January 24, 1992  
LD-92-007

Docket No. 52-002

Subject: Response to NRC Requests for Additional Information

RESPONSE TO NRC REQUESTS FOR ADDITIONAL INFORMATION  
MATERIALS AND CHEMICAL ENGINEERING BRANCH,  
STRUCTURAL AND GEOSCIENCES BRANCH,  
PLANT SYSTEMS BRANCH

### E. LONGITUDINAL BREAKS

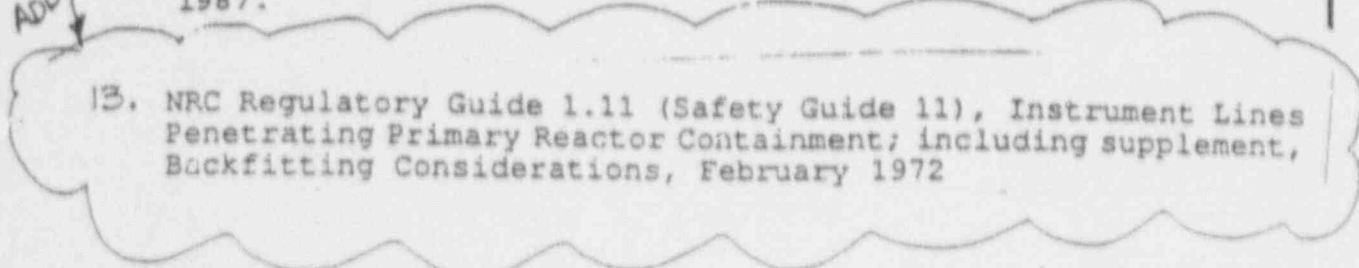
Provide justification for the differences between the BTP MEB 3-1, Rev. 2 and the CESSAR-DC criteria or modify the latter in accordance with former.

ADD ITEM E. AS SHOWN ON ATTACHED PAGE.

A longitudinal break results in an axial split without severance. The split shall be assumed to be orientated at any point about the circumference of the pipe, or alternatively at the point of highest stress as justified by detailed stress analyses. For the purpose of design, the longitudinal break shall be assumed to be circular or elliptical ( $2D \times 1/2D$ ) in shape, with an area equal to the largest piping cross-sectional flow area at the point of the break and have a discharge coefficient of 1.0. Any other values used for the area, diameter and discharge coefficient associated with a longitudinal break shall be verified by test data which defines the limiting break geometry.

COMBINED SMALL BREAK LOCA AND SSE LOADINGS

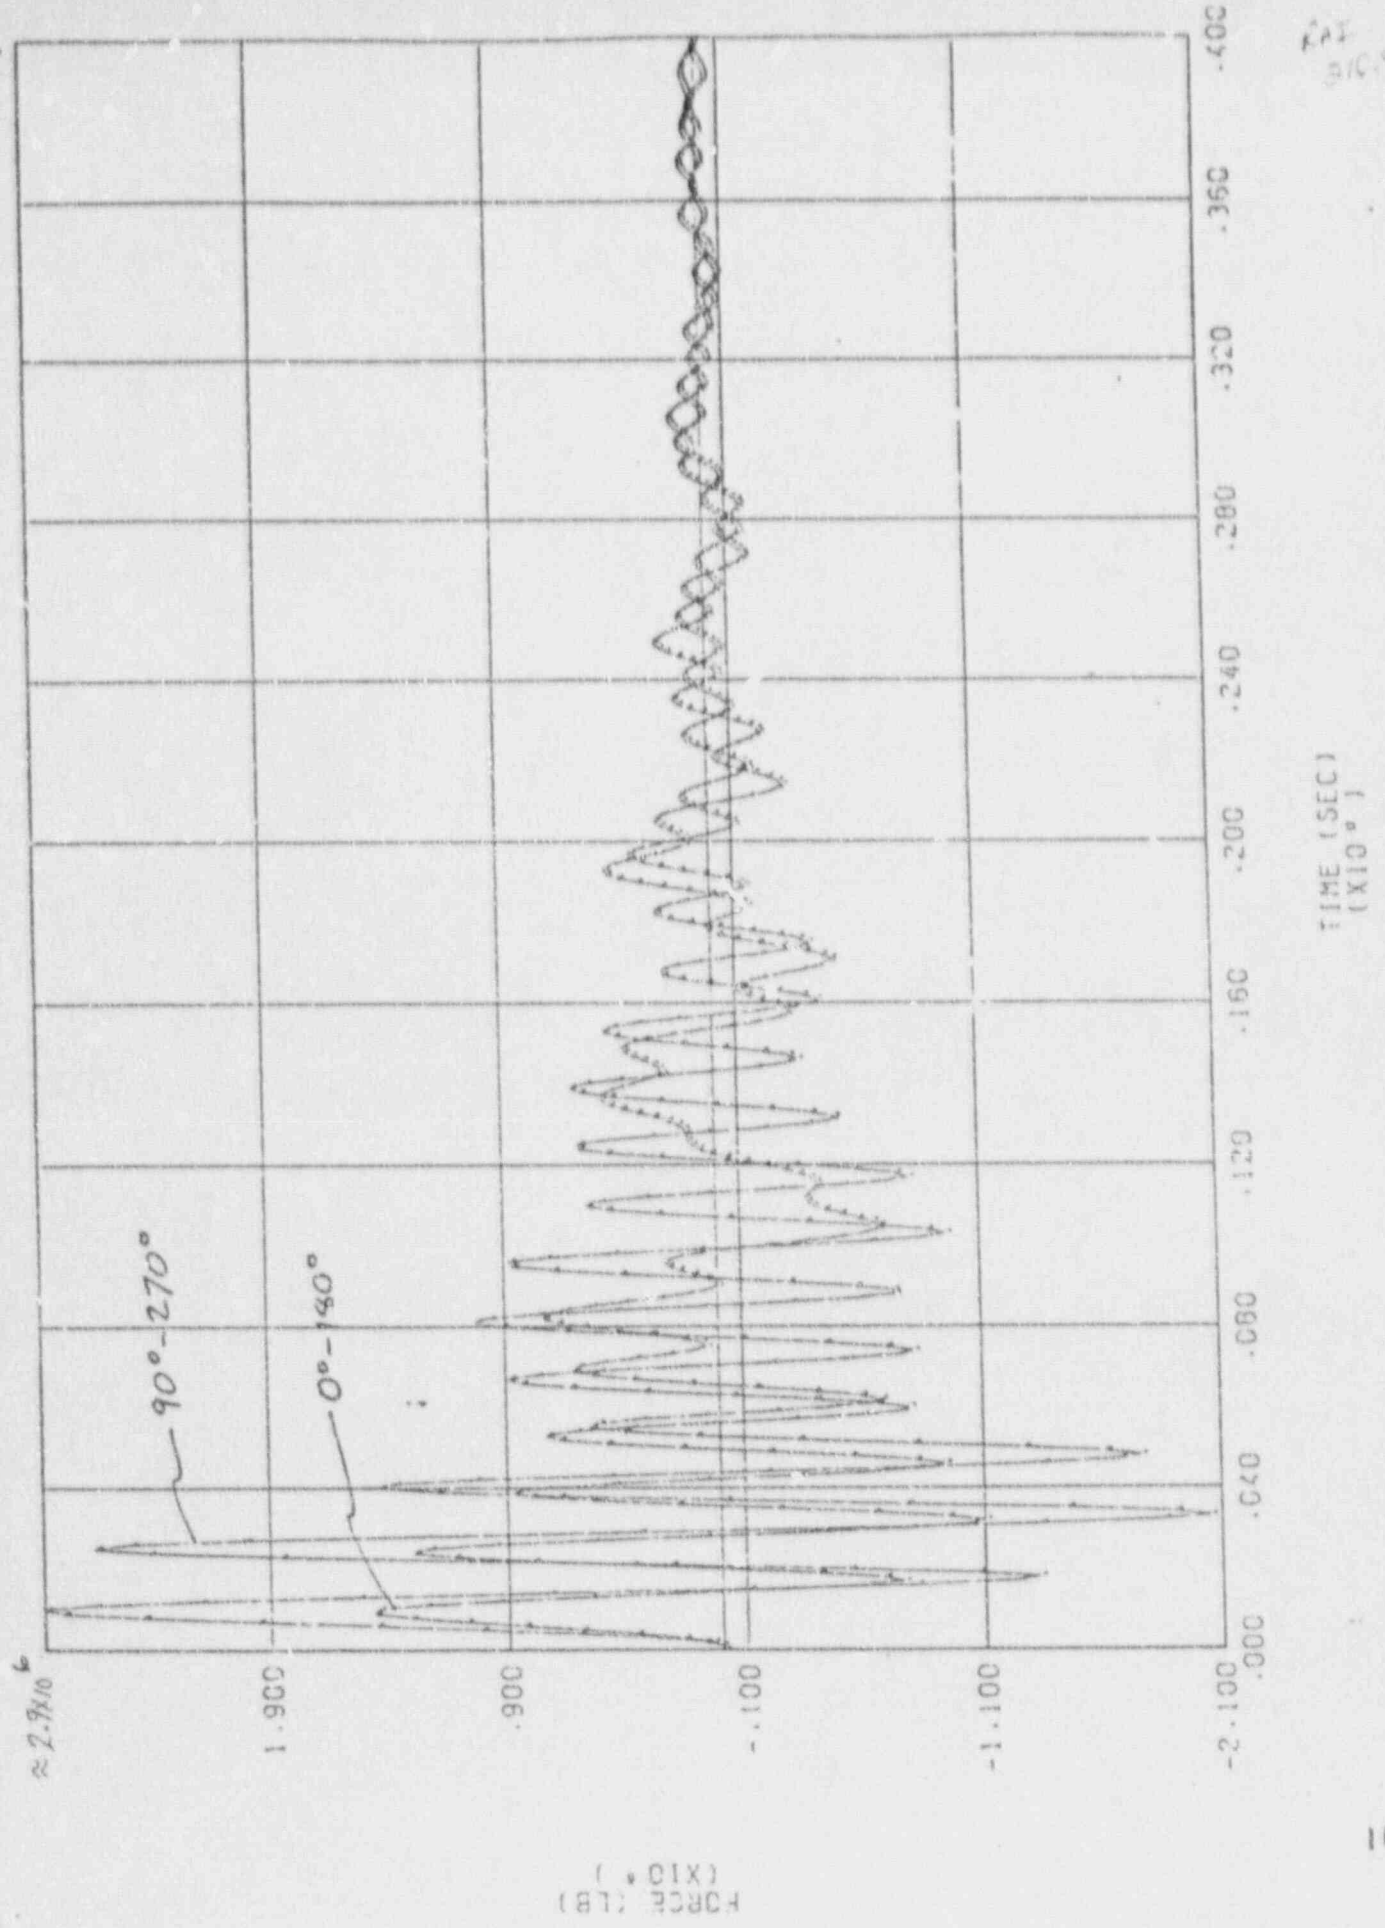
With respect to increasing the SSE loads by a small factor to account for asymmetric blowdown loads associated with a small break LOCA, provide explanations of the magnitude, direction and dynamic nature of the blowdown loads to verify the adequacy of the factor used.

A typical small cold leg break LOCA blowdown response is shown in attached Figure 1. Two curves are presented, one

for the resultant load parallel to the hot legs and the other perpendicular to the hot legs. Also, a study was made to determine the System 80+ internals responses for a 30 inch cold leg break. Table . . . shows the resulting peak component shear loads and moments and SSE response loads. The results show in all cases that the combined SRSS design load increases are less than 10 percent since the LOCA loads are all less than 0.46 times the SSE loads, thus verifying the adequacy of the factor used.
